**QUALCOMM Incorporated**

March 29, 2012

**Re: Petition for Rulemaking To Establish A Next Generation Air-Ground  
Service On A Secondary Licensed Basis In The 14.0 to 14.5 GHz Band,  
RM-11640**

## Attachment – Qualcomm Follow-on Responses to FCC Staff Technical Questions

**Figure 3: 8 x 8 Modified Layout to Handle Increased Traffic In Lower Right Region**

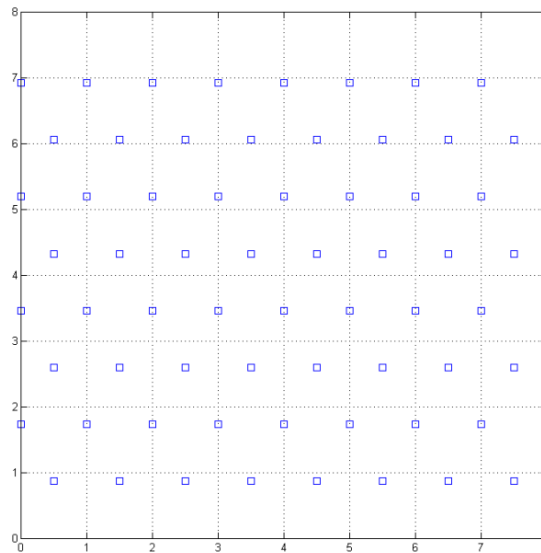
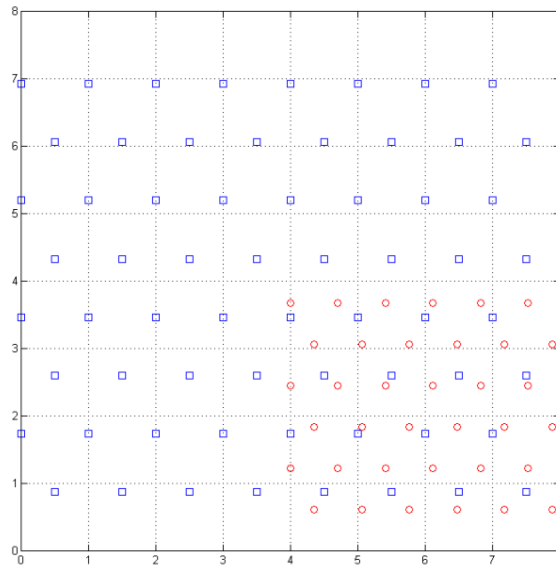
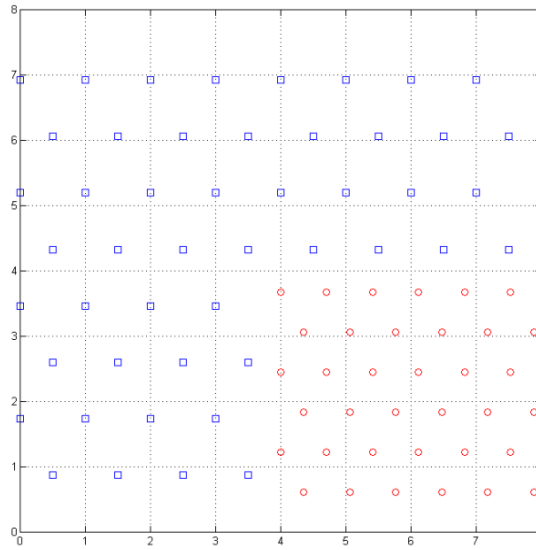
*The FCC IB January 19, 2012, letter asked: [G]iven that the distribution of aircraft is not uniform and the number of aircraft per square mile can be significantly higher over certain airports, how will you compensate for this uneven aircraft distribution to ensure no FSS satellite receiver will receive more than the calculated interference?*

Now suppose the lower right 4 x 4 square region is a region with twice the aircraft density,  $2\rho$ . If the standard layout is not able to provide sufficient capacity to handle the increased traffic in the lower right square region, the Next-Gen AG network may be enhanced through “cell splitting”. This may be accomplished by doubling the density of GSs in this region. Referring to Figure 2, the 4 x 4 region that originally contained 16 GSs (in blue) is now served with 36 GSs (in red), with a site-to-site separation reduced by a factor of approximately  $1/\sqrt{2}$ . In other words, in this more dense cell configuration, the site-to-site spacing has been reduced from 250 km to 175 km and the coverage radius has been reduced from 300 km to 212 km. The new layout is shown in Figure 3, with the higher density sites depicted in red to distinguish them from the standard sites in blue.

Because the number of sites in the lower 4x4 square region has increased from 16 to 36, in order to hold the overall interference power to the geo-arc fixed, the transmit power of each red site is decreased by a factor of  $36/16 = 3.5$  dB. The transmit power for the remaining original blue sites are not modified, so their coverage areas and overall capacity remain virtually unchanged.<sup>1</sup>

**Figure 4. Single interfering OFDM signal.  $\Delta f = 15$  kHz,  $W_2 = 64$  kHz**

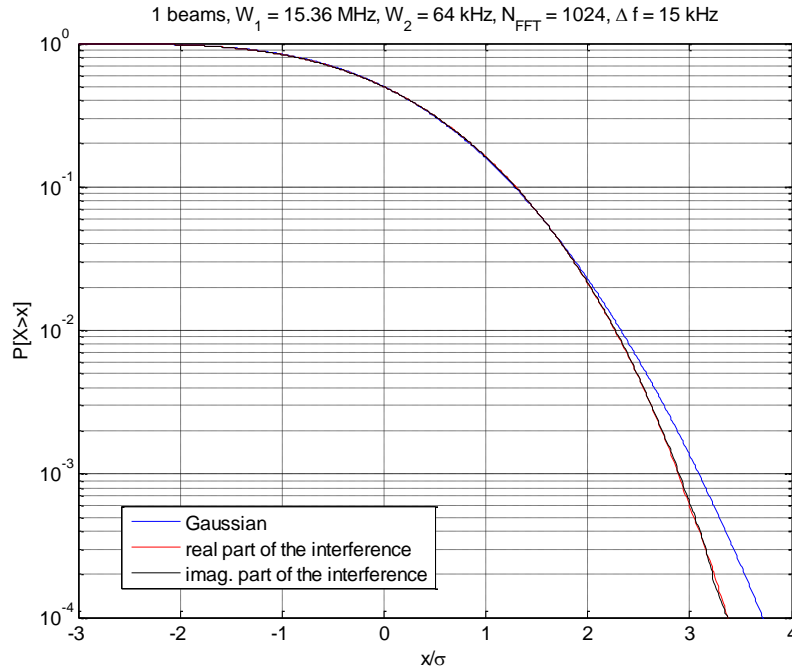
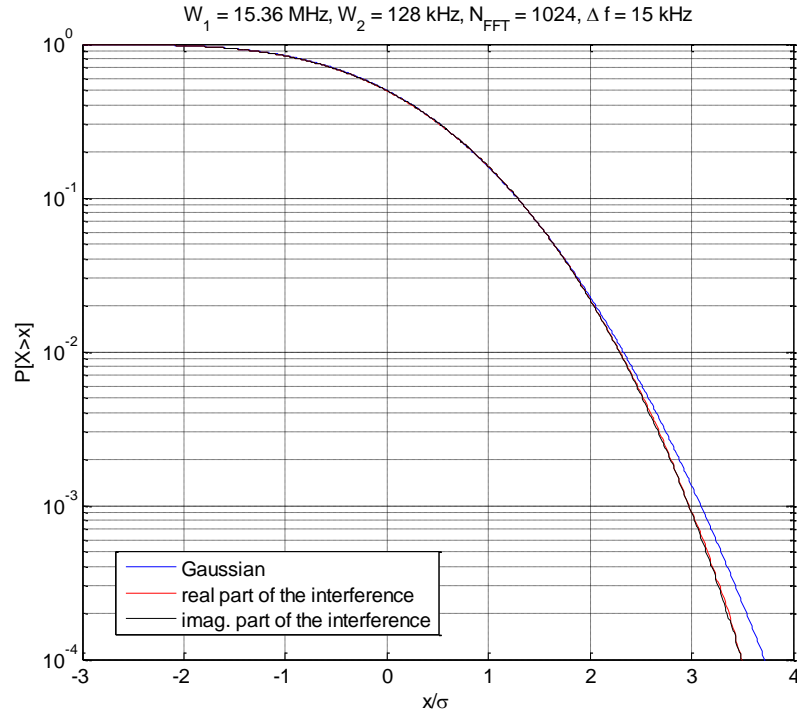
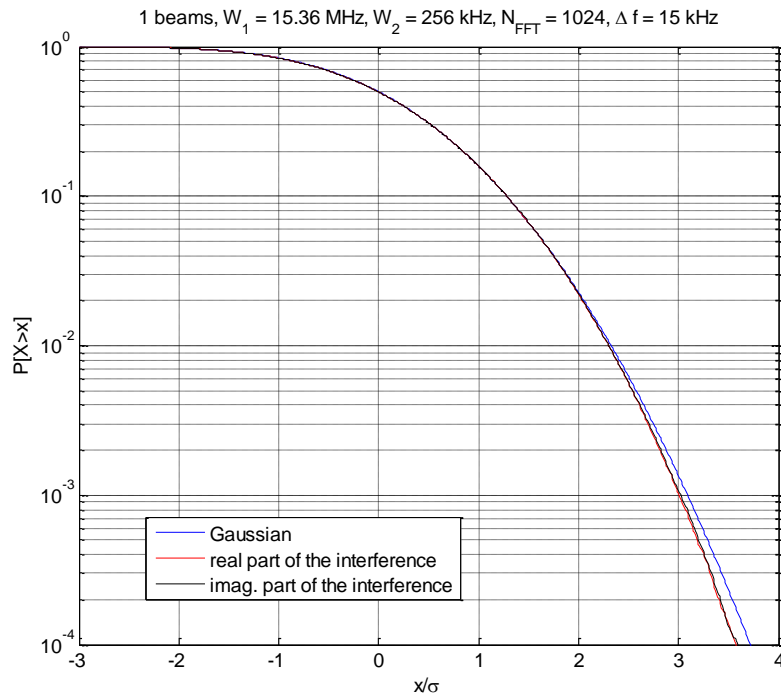
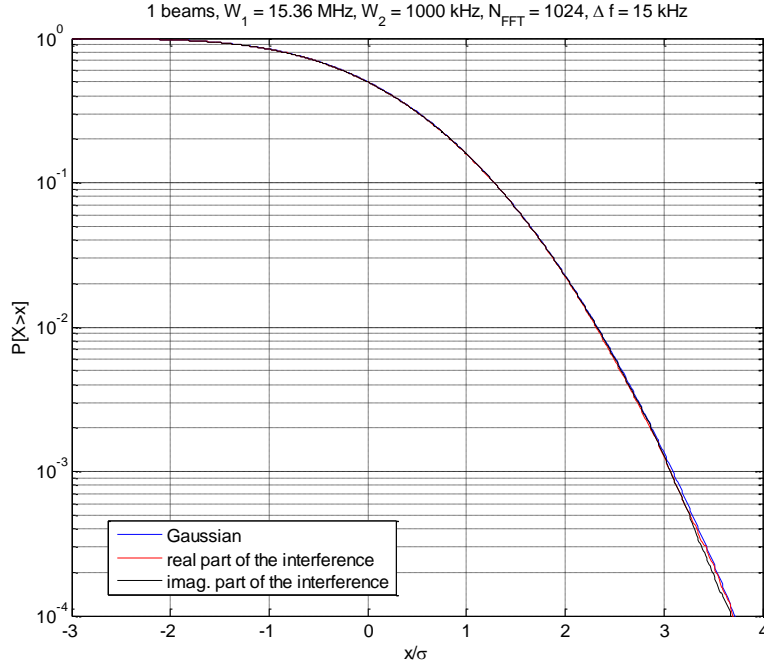
*The FCC IB January 19, 2012, letter asked: Is your interference analysis based on peak or average power? If it is based on average power, please inform us of your expected peak-to-average power ratio.*

The transmitted OFDM signal has 1024 tones loaded with QPSK modulation symbols, and its bandwidth  $W_1 = 15.36$  MHz. The tone spacing  $\Delta f = 15$  kHz. Consider a satellite channel bandwidth of  $W_2 = 64$  kHz. The complementary cumulative distribution function (“CCDF”) of the envelope of the Nyquist rate (64 kHz) output samples relative to average power of the signal is shown in Figure 4 below. In this case, the major contribution to the interference samples is from the roughly  $64/15 \approx 4$  tones within the satellite channel bandwidth  $W_2 = 64$  kHz.

Notice that the tail of the interference sample distribution decays faster than that of a Gaussian random variable. In other words, the wideband interference does not have a higher peak-to-average ratio than that of a Gaussian random variable of the same power. Since the tail of the distribution is what determines the performance of a receiver for the narrowband satellite channel, treating the wideband interference as Gaussian distributed is a conservative approximation.

Figure 5, Figure 6, and Figure 7 below show the CCDF of the Nyquist rate output samples when the satellite channel bandwidth  $W_2$  is increased to 128 kHz, 256 kHz, and 1 MHz, respectively. The number of tones that contribute significantly to the output samples is 9, 17, and 67 tones for 128 kHz, 256 kHz, 1 MHz, respectively. The Figures below show that as this number increases, the CCDF converges closer to that of a Gaussian random variable. Notice that in all the cases, CCDFs show that the output samples are less “peaky” than Gaussian random variable of the same power.
